Project No. 1886.00

February 28, 2019

ADDENDUM NO. 3
TO THE
DRAWINGS AND PROJECT MANUAL
FOR
**CONTROLLED ENTRY AT 15 CAMPUSES
BIRDVILLE ISD
NORTH RICHLAND HILLS, HALTOM CITY, HURST AND WATAUGA, TEXAS**

4 GLAZED OPENING ELEVATIONS
SCALE: 1/4"=1'-0"

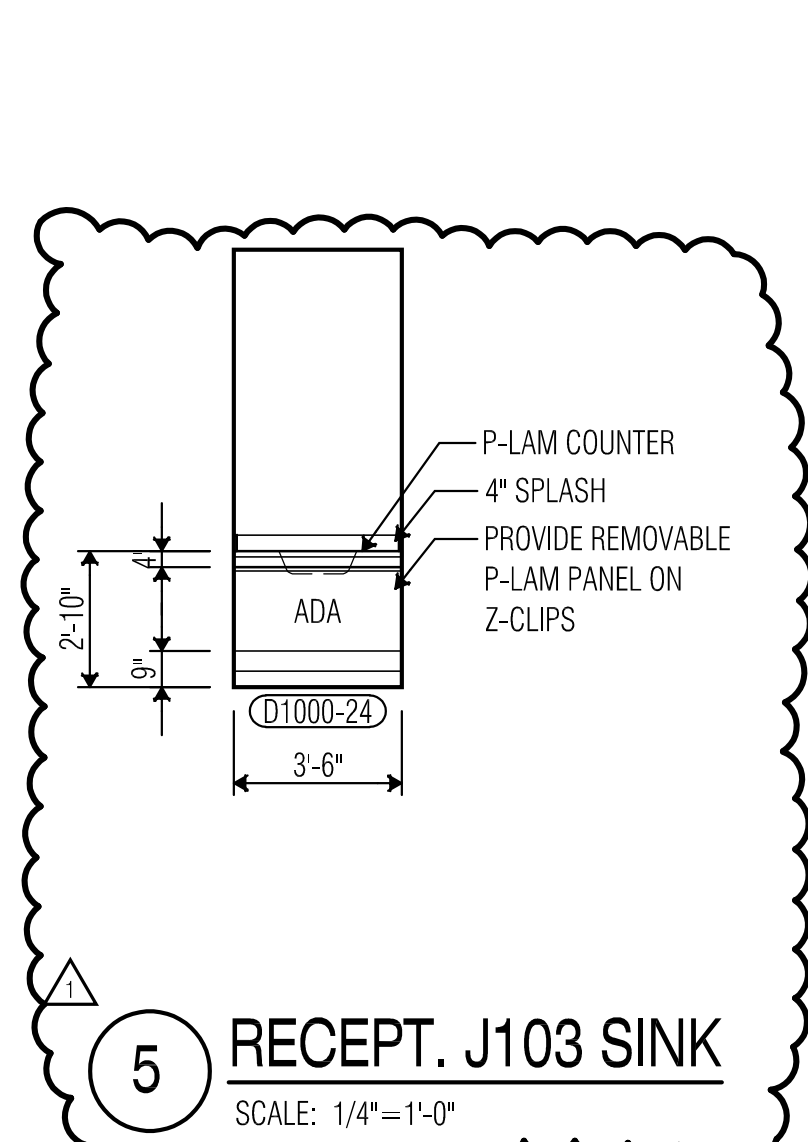
1. In Vest. J100, on note "Vest. J100 into main campus: Alt. Bid #1: BR-1 on glazing up to 9'-1 3/8"; Alt. Bid #2: BR-2 on glazing up to 9'-1 3/8", revise note to read: "VEST. J100 INTO MAIN CAMPUS: ALT. BID #2: BR-1 ON ALL GLAZING UP TO 9'-1 3/8" AFF; ALT. BID #3: BR-2 ON ALL GLAZING UP TO 9'-1 3/8" AFF".
2. On door J103A, in glazed opening G.O.-J1, and all associated glazing up to 9'-1 3/8" AFF, to have Alternates 2 and 3.
3. On existing Storefront containing doors J100E, J100F, J100G, and J100H up to 9'-1 3/8" AFF, to have Alternates 2 and 3.

10 FINISH FLOOR PLAN - C.F. THOMAS ES
SCALE: 1/8"=1'-0"

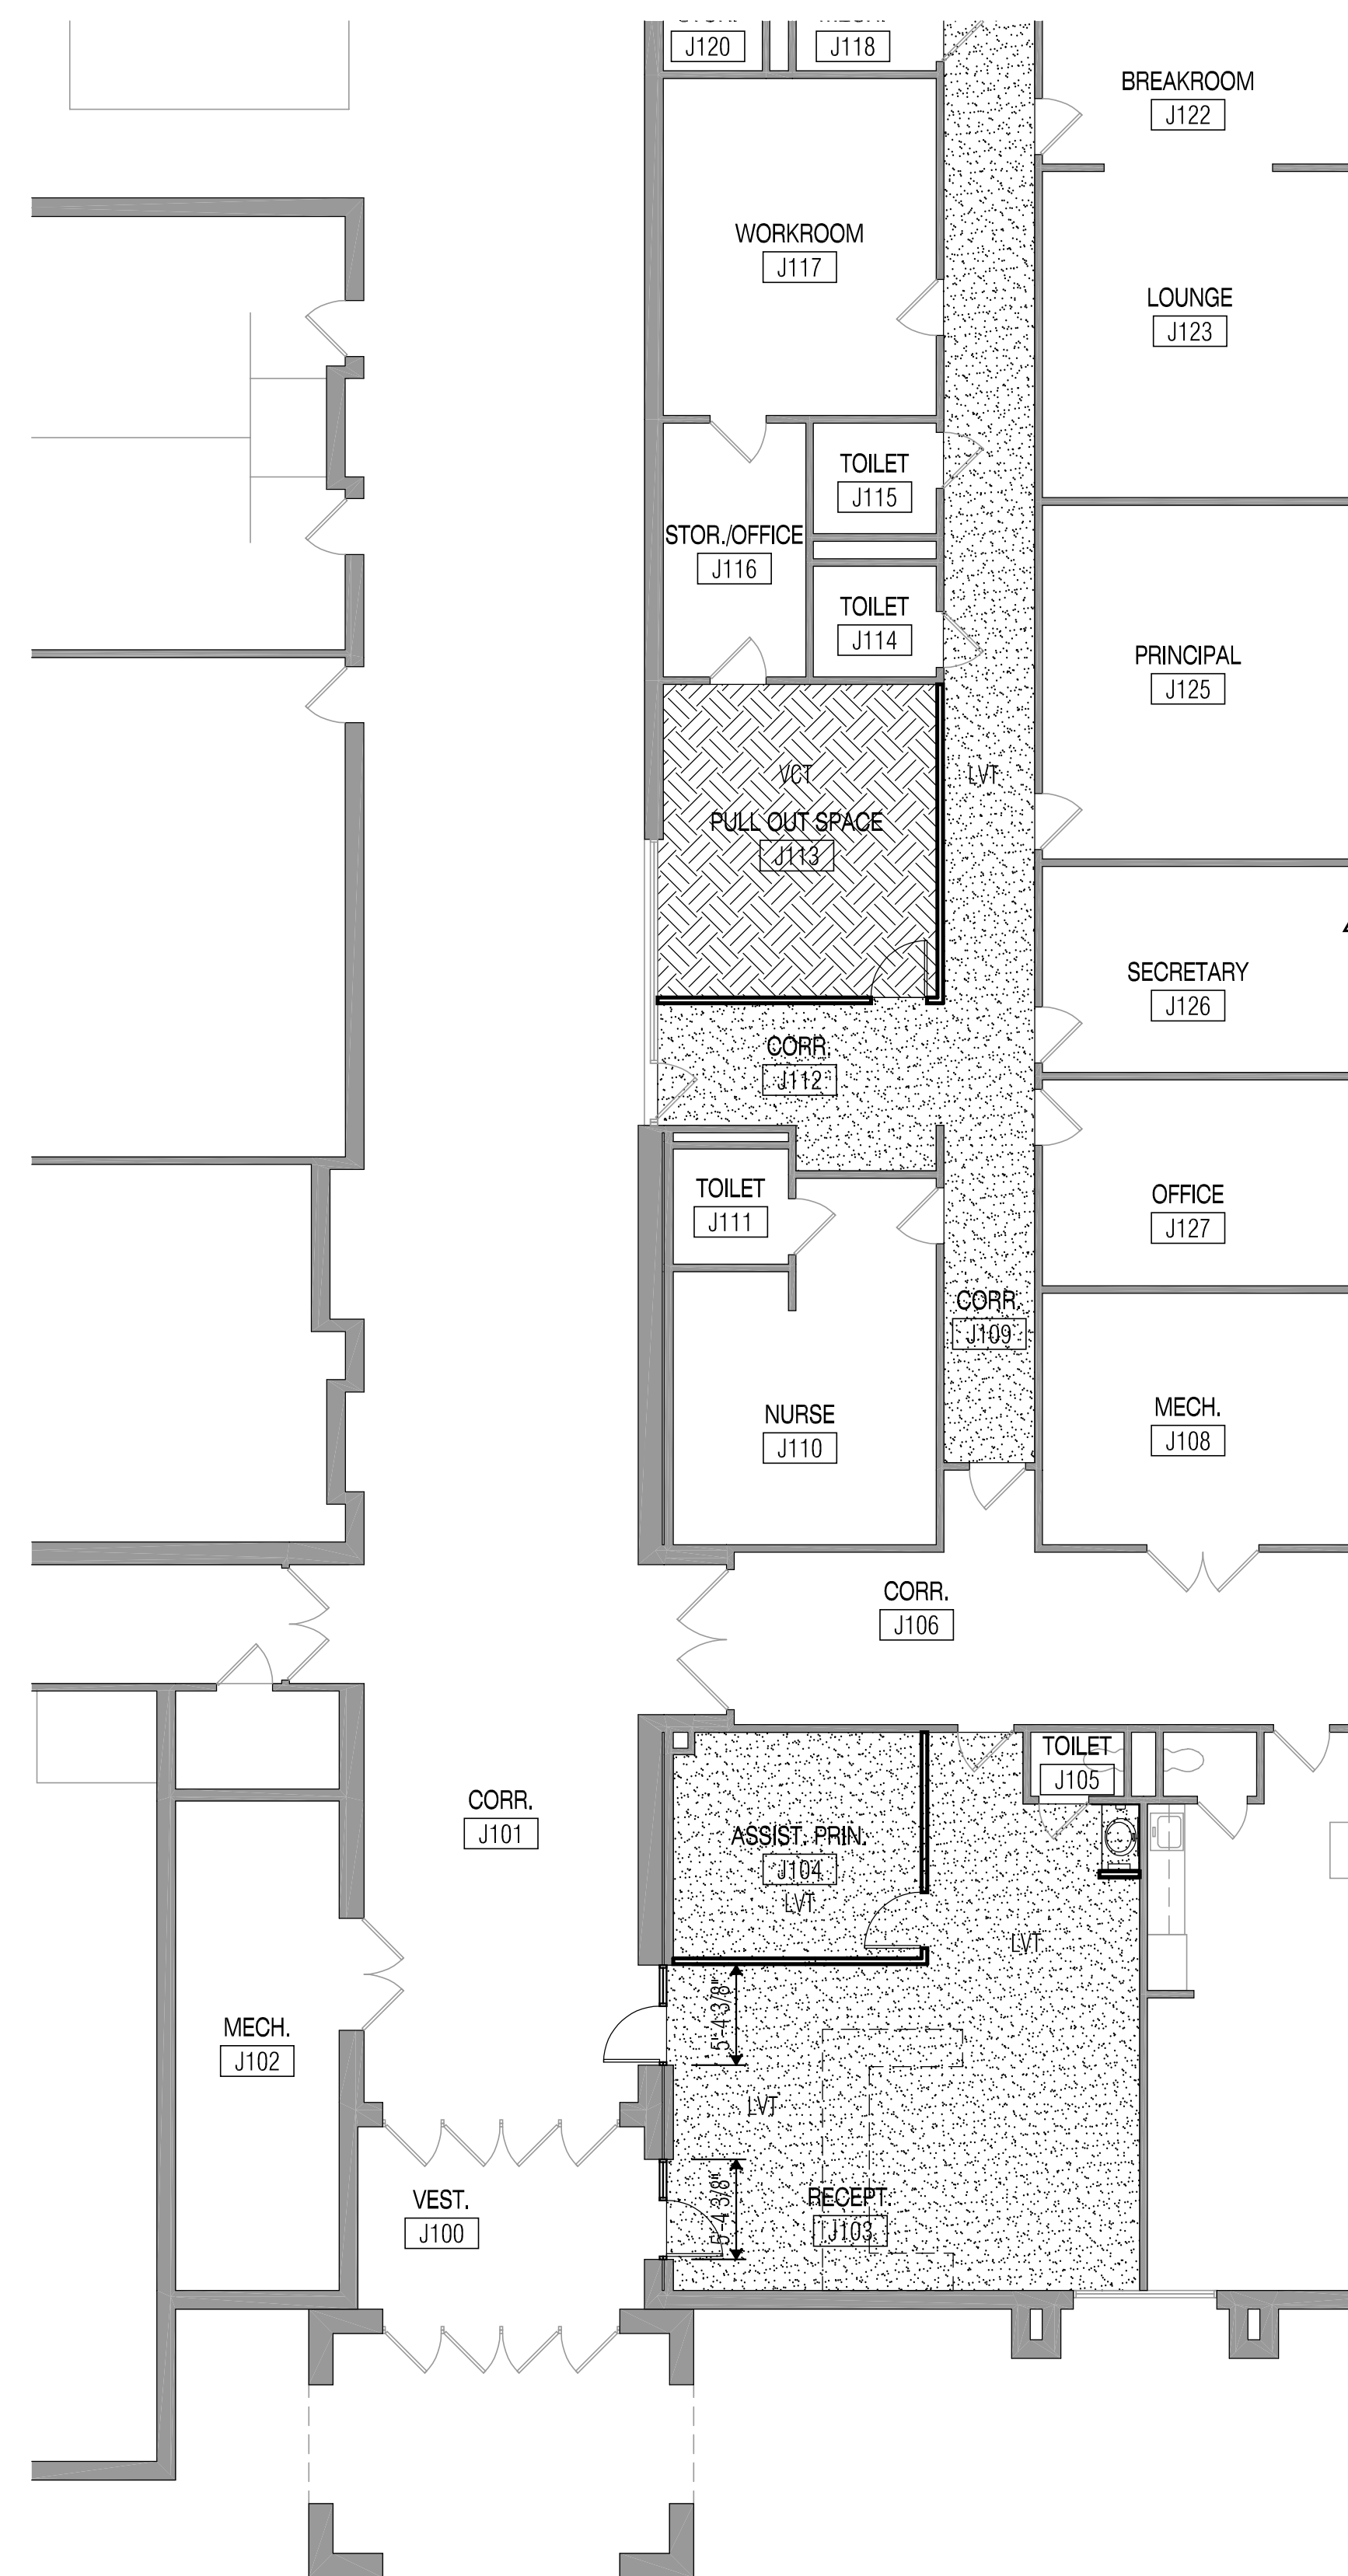
1. In Toilet J105, remove existing wall covering in entire room & prepare wall for new ceramic wall tile.

4 GLAZED OPENING ELEVATIONS
SCALE: 1/4"=1'-0"

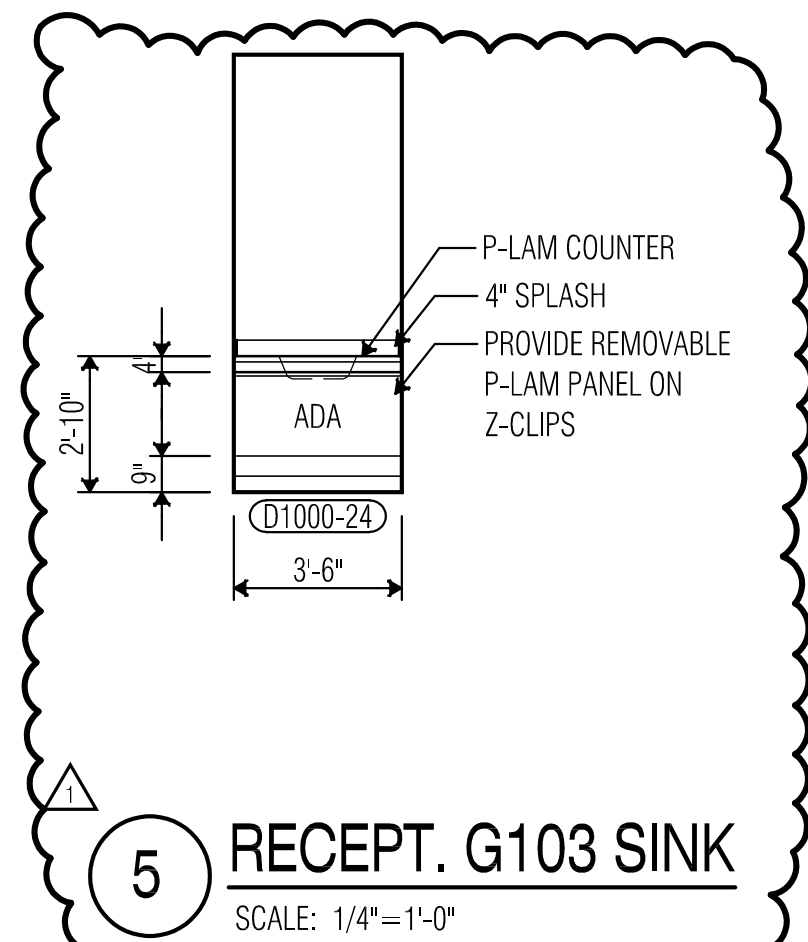
1. In Vest. G100, on note "Vest. G100 into main campus: Alt. Bid #1: BR-1 on glazing up to 9'-1 3/8"; Alt. Bid #2: BR-2 on glazing up to 9'-1 3/8", revise note to read: "VEST. G100 INTO MAIN CAMPUS: ALT. BID #2: BR-1 ON ALL GLAZING UP TO 9'-1 3/8" AFF; ALT. BID #3: BR-2 ON ALL GLAZING UP TO 9'-1 3/8" AFF".
2. On door G103A, in glazed opening G.O.-G1, and all associated glazing up to 9'-1 3/8" AFF, to have Alternates 2 and 3.
3. On existing Storefront containing doors G100E, G100F, G100G, and G100H up to 9'-1 3/8" AFF, to have Alternates 2 and 3.

10 FINISH FLOOR PLAN - JOHN D. SPICER ES
SCALE: 1/8"=1'-0"

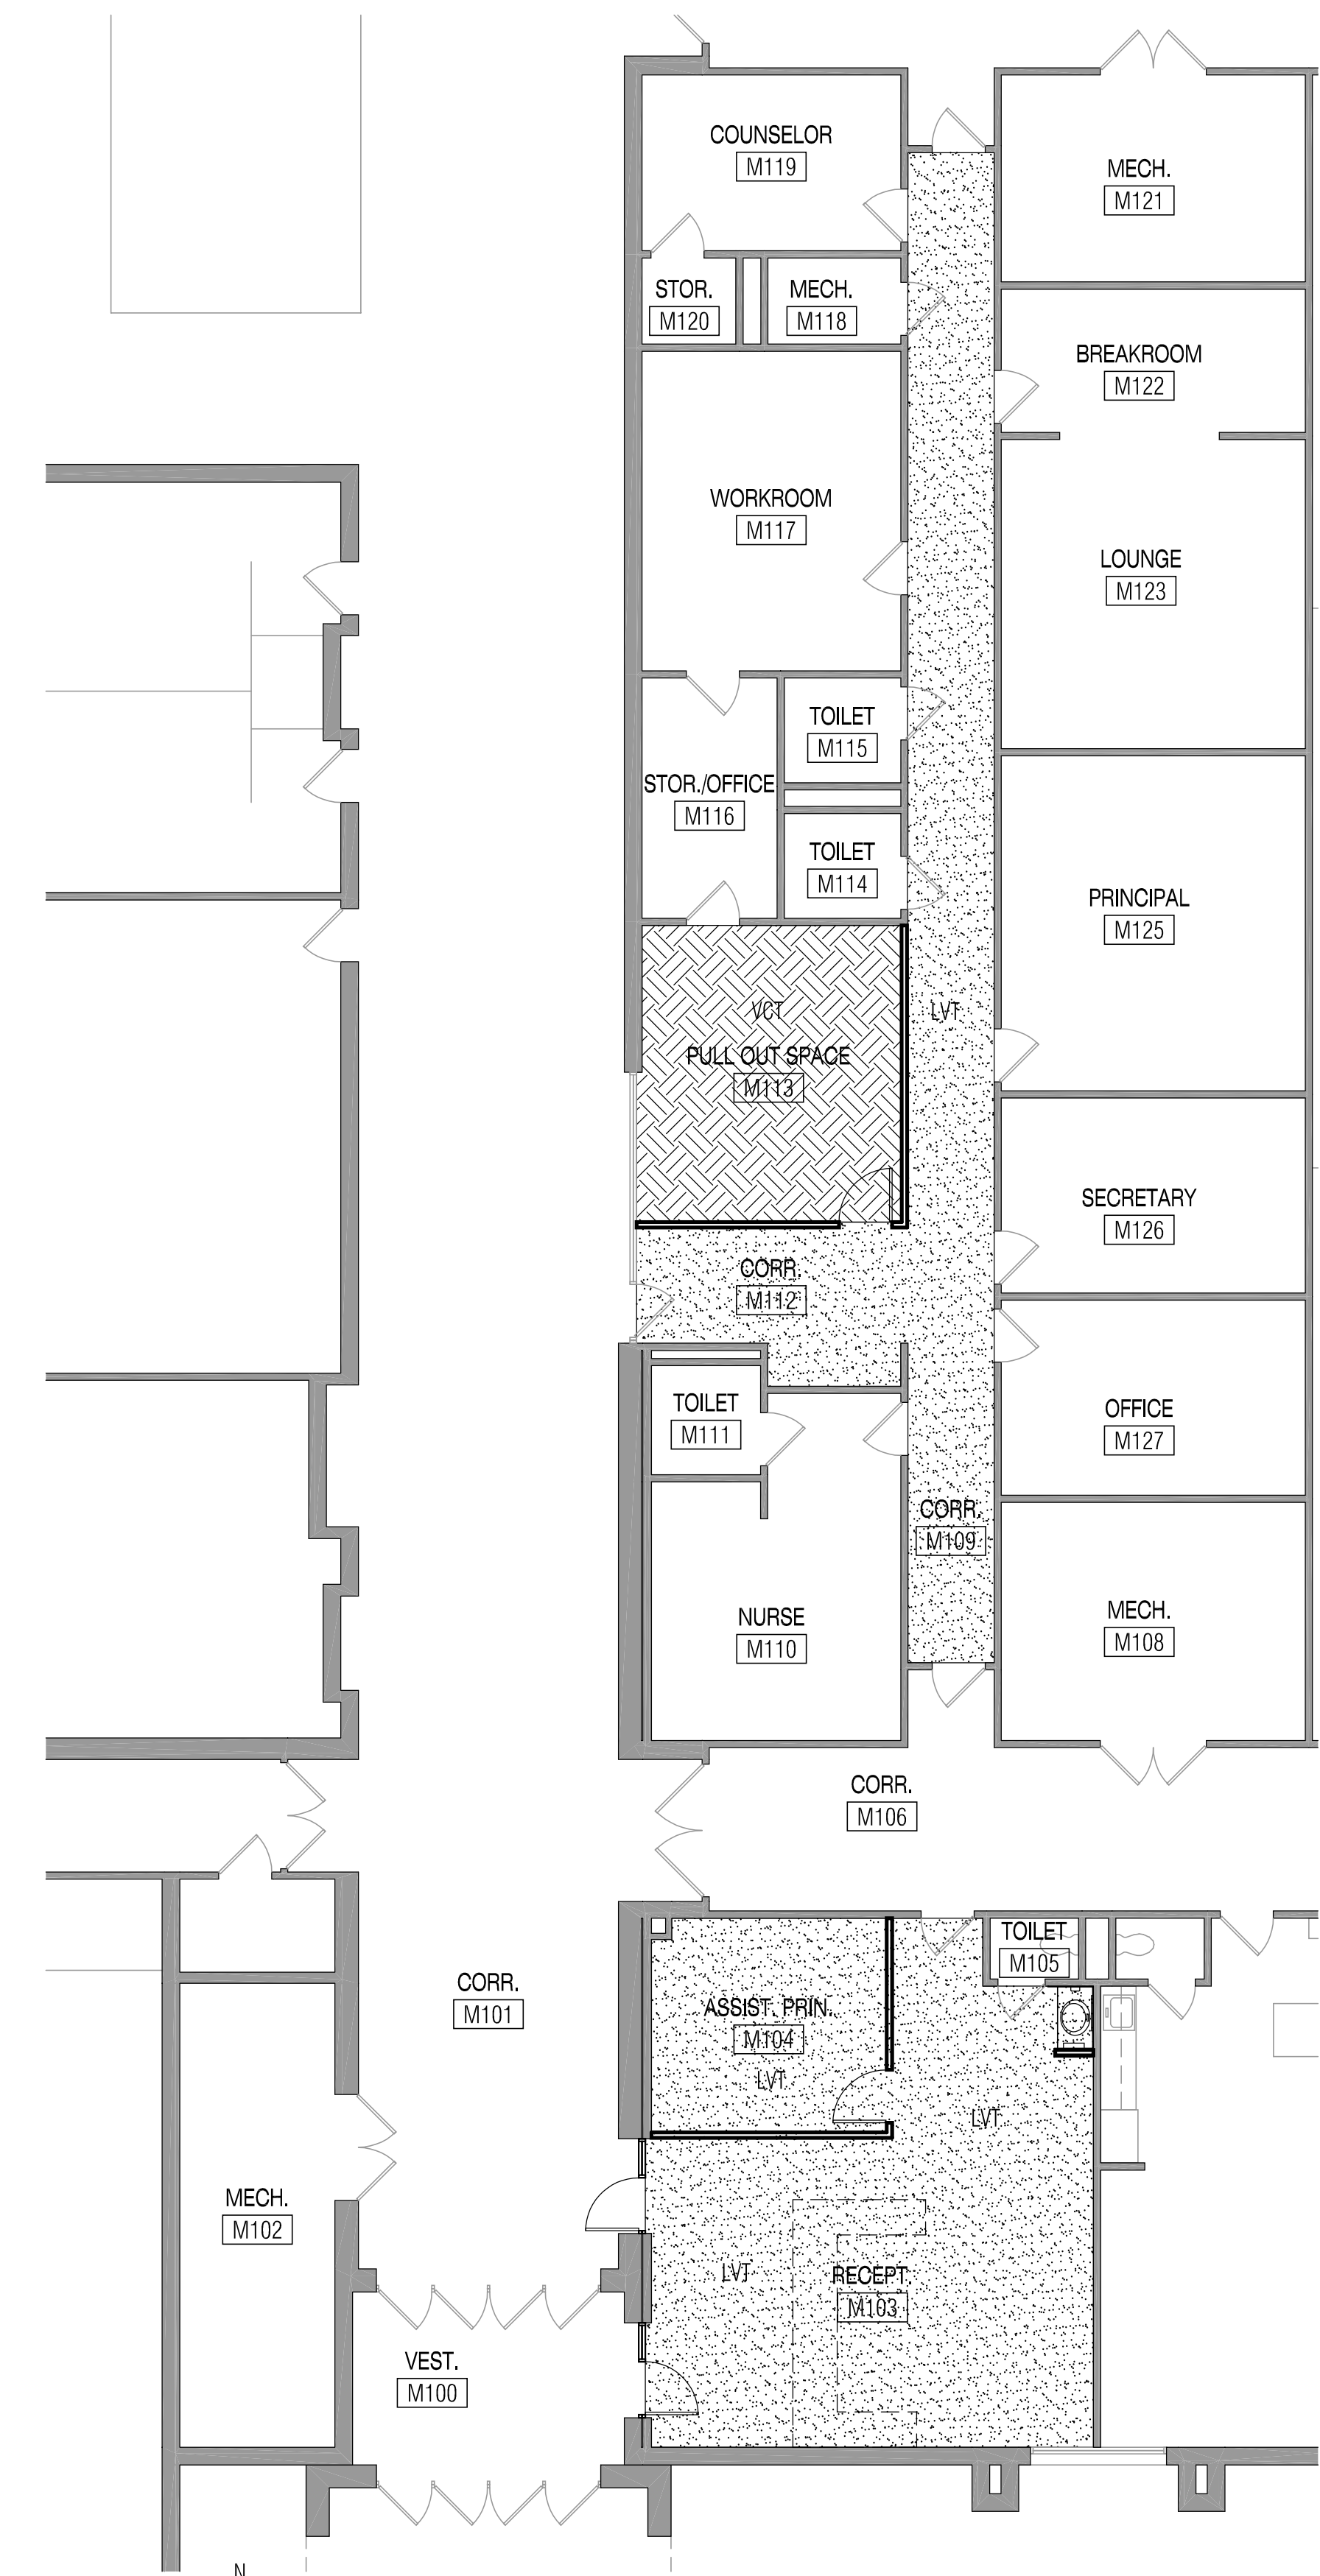
- A. DEMO FLOOR PLAN – JOHN D. SPICER ES – PLAN 1:
1. In Toilet M105, remove existing wall covering in entire room & prepare wall for new ceramic wall tile.
- B. FLOOR PLAN – JOHN D. SPICER ES – PLAN 2:
1. In Vest. M100, on note “Vest. M100 into main campus: Alt. Bid #1: BR-1 on glazing up to 9’-1 3/8””; Alt. Bid #2: BR-2 on glazing up to 9’-1 3/8””, revise note to read: “VEST. M100 INTO MAIN CAMPUS: ALT. BID #2: BR-1 ON ALL GLAZING UP TO 9’-1 3/8” AFF; ALT. BID #3: BR-2 ON ALL GLAZING UP TO 9’-1 3/8” AFF”.
 2. On door M103A, in glazed opening G.O.-M1, and associated glazing up to 9’-1 3/8” AFF, to have Alternates 2 and 3.
 3. On existing Storefront containing doors M100E, M100F, M100G, and M100H up to 9’-1 3/8” AFF, to have Alternates 2 and 3.

4 STOREFRONT ELEVATIONS
SCALE: 1/4"=1'-0"

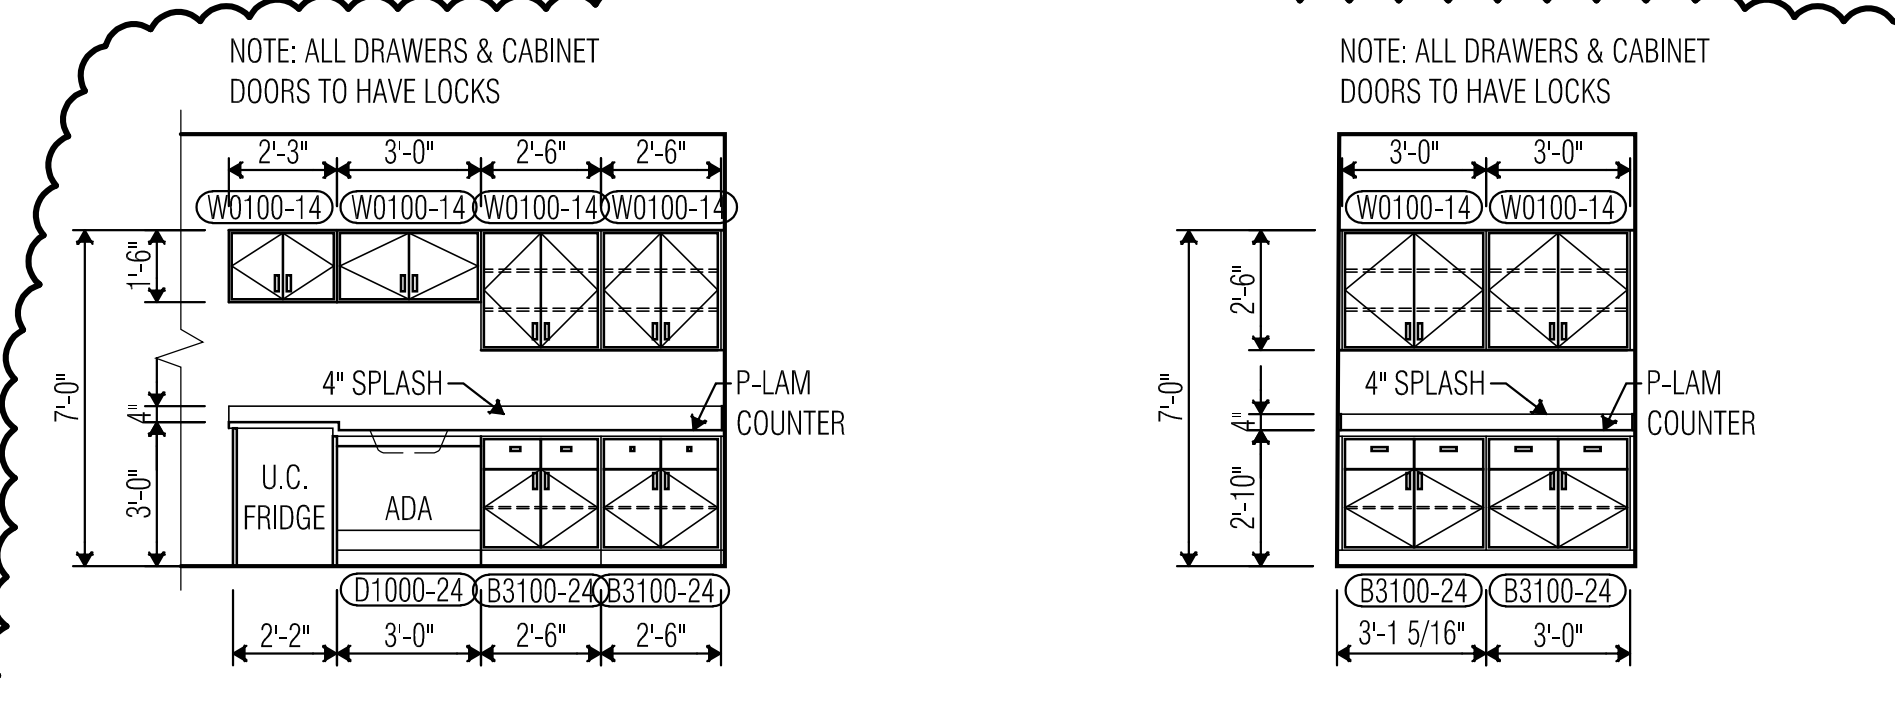
- A. FLOOR PLAN – W.A. PORTER ES – PLAN 2:
1. In Vest. N100, on note “Vest. N100 into main campus: Alt. Bid #1: BR-1 on glazing up to 9’-1 3/8””; Alt. Bid #2: BR-2 on glazing up to 9’-1 3/8””, revise note to read: “VEST. N100 INTO MAIN CAMPUS: ALT. BID #2: BR-1 ON ALL GLAZING UP TO 9’-1 3/8” AFF; ALT. BID #3: BR-2 ON ALL GLAZING UP TO 9’-1 3/8” AFF”.
 2. On Storefront NA and NB up to 9’-1 3/8” AFF, to have Alternates 2 and 3.
